Design of the AV Production Studio and  
Addition to the Training Institute at NARC  
and  
Development of a Physical Master Plan for  
NARC

Consulting Reports 1-5  
(June 1986 - August 1988)

NARC FACILITY SURVEY REPORT • H. JAMES MILLER  
ASSIGNMENT ISLAMABAD, PAKISTAN USAID • WINROCK • ABRIS.

● NARC FACILITY SURVEY REPORT - H. James Miller, Architect, Planning Consultant  
Assignment in Pakistan, June 4 - 19, 1986

# Expansion Joint Covers: Interior

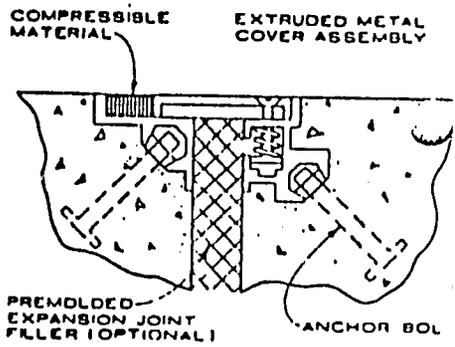
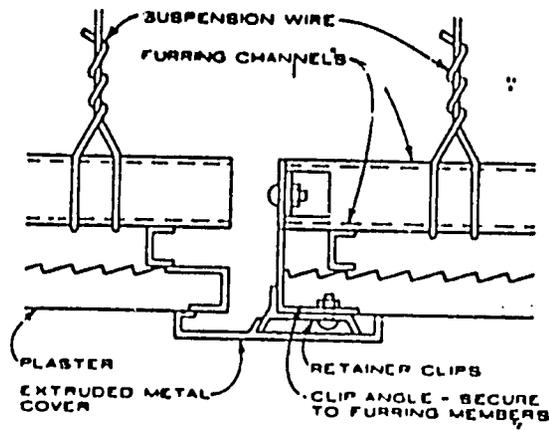
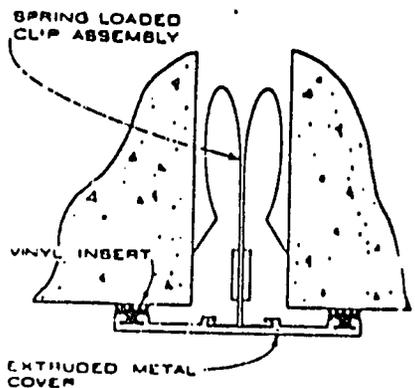
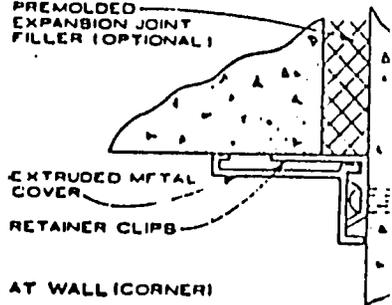
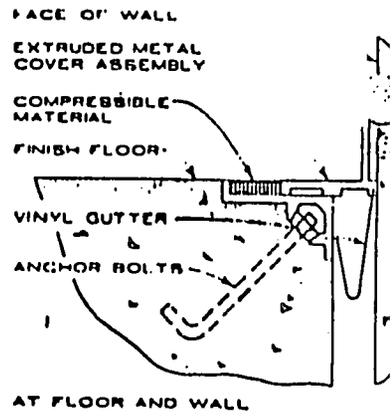
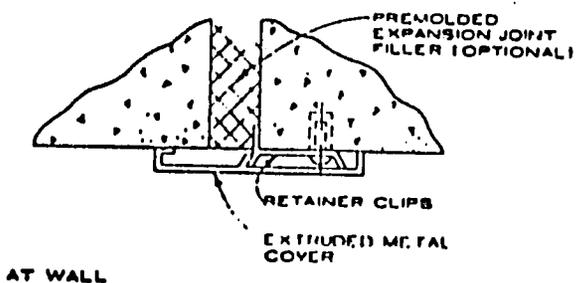
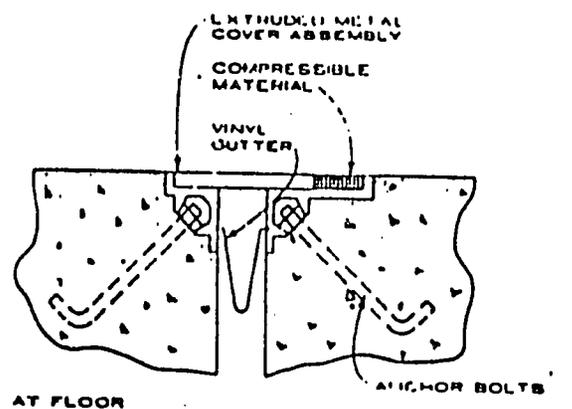
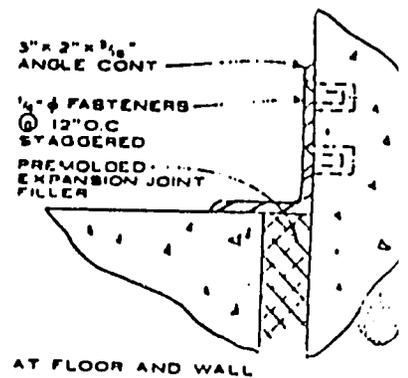
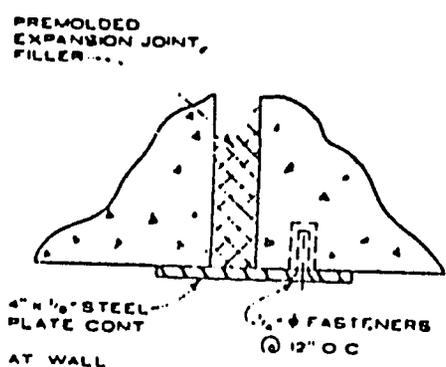
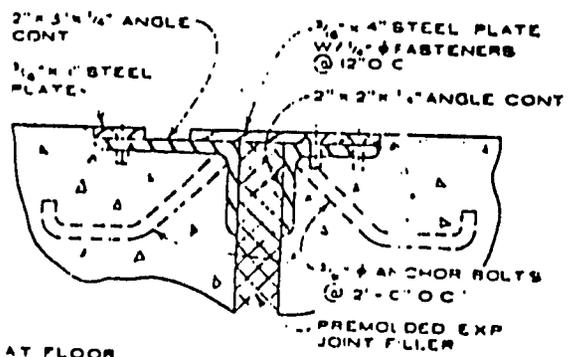
- (a) Expansion joint construction was faulty and incomplete.
- (b) Caulking of metal roof flashing is incomplete, and workmanship of roof waterproofing at some edges was faulty.
- (c) Sheet metal lining for roof drain gargoyles to throw water away from building were not provided as intended.

- (a) Expansion joints that are leaking can be corrected in several ways, all expensive. One way is to try to correct the flaws in the system already in place. Though this may not be a longterm solution (it is cheapest and is already being attempted with some success). A second way is to break away the slabs and install more sophisticated imported plate and angle covers for the joints. This may be the only long range permanent solution and is preferred. A third way is to utilize one of the special synthetic silicone or butyl rubber materials that would seal the joint, adhering to both surfaces and allowing movement.

**NOTE**  
Expansion joint covers that will respond to different movement, both laterally and horizontally should be provided at joints in structures located where seismic action (earth tremors and quakes) may be expected where differential settlement is anticipated.

**NOTE**  
A large selection of prefabricated assemblies to cover interior expansion joints are available from various manufacturers to satisfy most joint and finish conditions.

# SCUPPER METAL LINER.

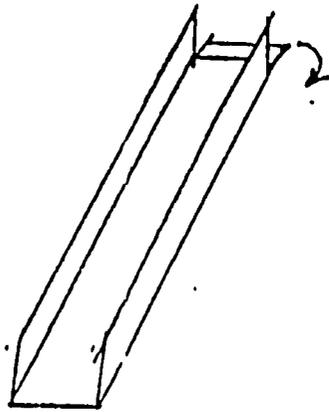
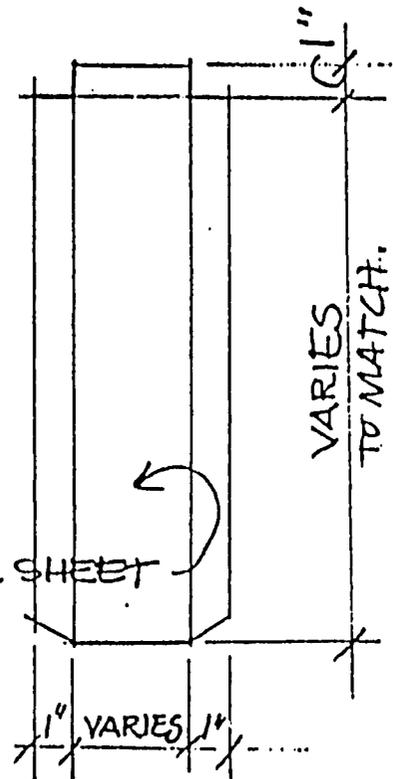
the walls, but instead allow it to run down the surface. The problem is due to missing metal liners that were supposed to project out from each opening to cause the water to fall into the gravel bed below, without hitting the wall. These must be installed to correct the problem. (see sketch). The only other alternative is to install unsightly downpipe drains.

NOTE: COPPER SCUPPER LINER  
MUST FIT TIGHT TO CONCRETE.

# ADMINISTRATION BLOCK ATRIUM

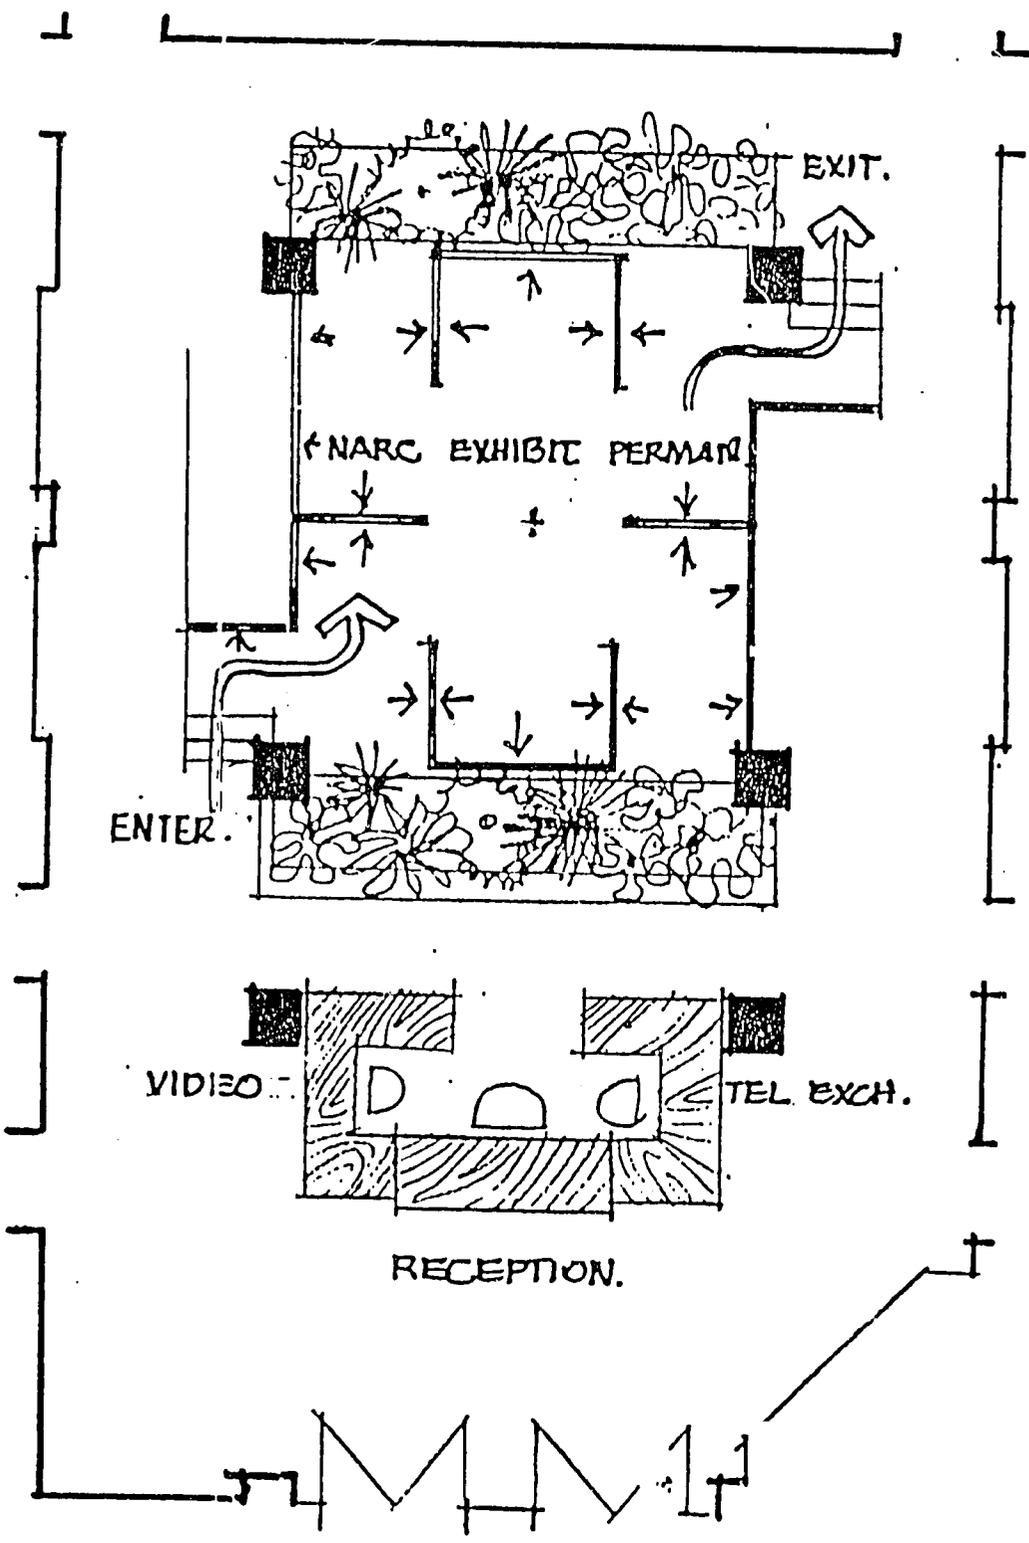
The central atrium space could be developed in a number of ways. It could be an elegant waiting area if properly furnished, an executive lounge where VIPs would be received and initial introductions conducted before proceeding to other parts of the complex. (Like the old palace reception courts). Alternately, the atrium could be developed as a professional permanent photographic exhibition of Pakistani agriculture, an inspirational and attractive educational tool for all VIP's arriving at the Center. Another idea would be to construct a large attractive model of the research farm and place it in the center of the atrium, so that visitors could be taken in a tour with a pointer. Or there could be a combination of these. Proper lighting, carpets on floors and stairs, paintings and other furnishing must be well designed by professionals to achieve the desired result. (see sketch diagram)

DESIGN EXHIBITION SYSTEM, LIGHTING, FURNITURE.

MULTI-PURPOSE HALL  
DESIGN EXHIBITION SYSTEM  
LIGHTING, FURNITURE.

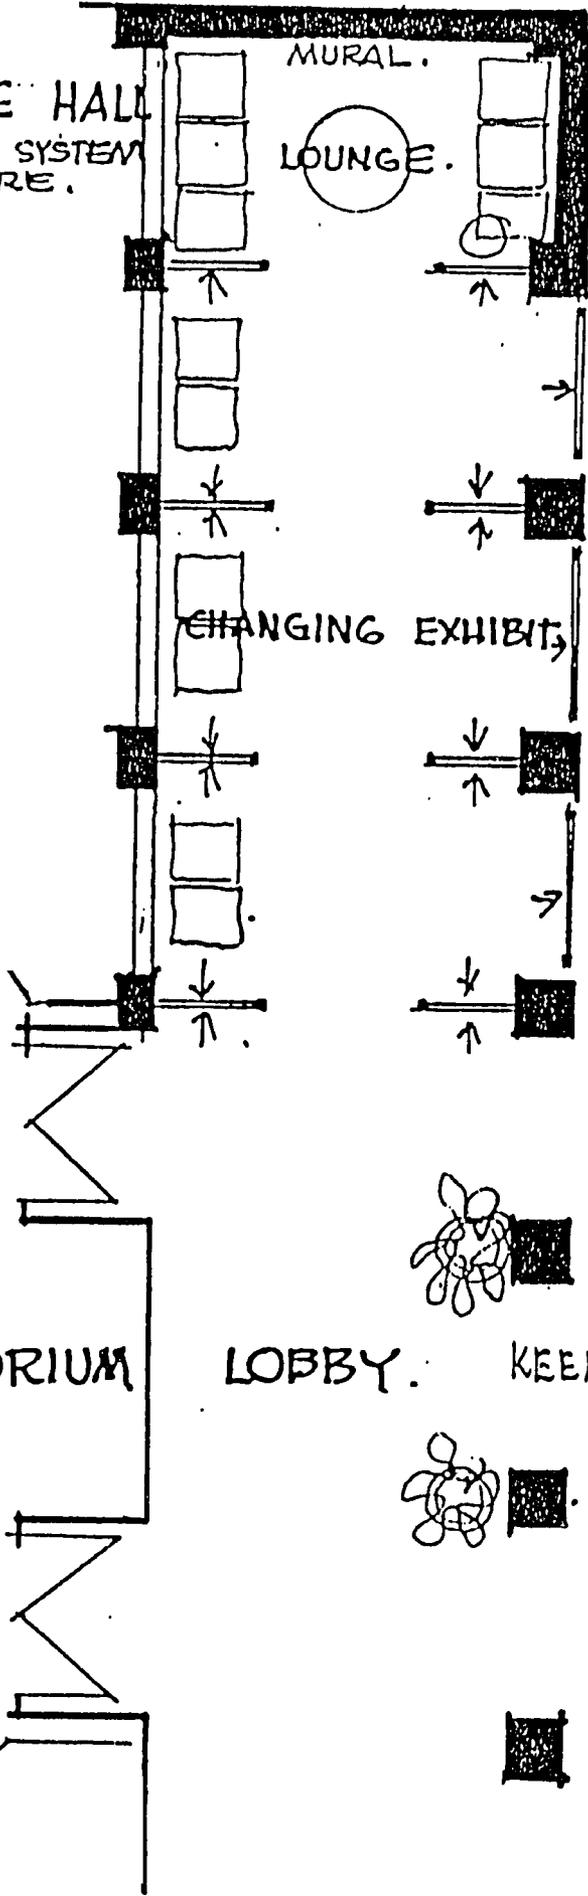
- (c) Improvements to Auditorium lobby: This linear space was designed for multi-purpose use. It is primarily a lobby area for people to spill into after lectures and for setting up tables for tea and other refreshments during conferences. It was also designed for changing exhibits. Next to Documentation, the space could be used for displays of various kinds. What is lacking is an exhibition system with proper flexible lighting. The system must be attractively designed, then the space can be very effectively utilized. (see sketch diagram)
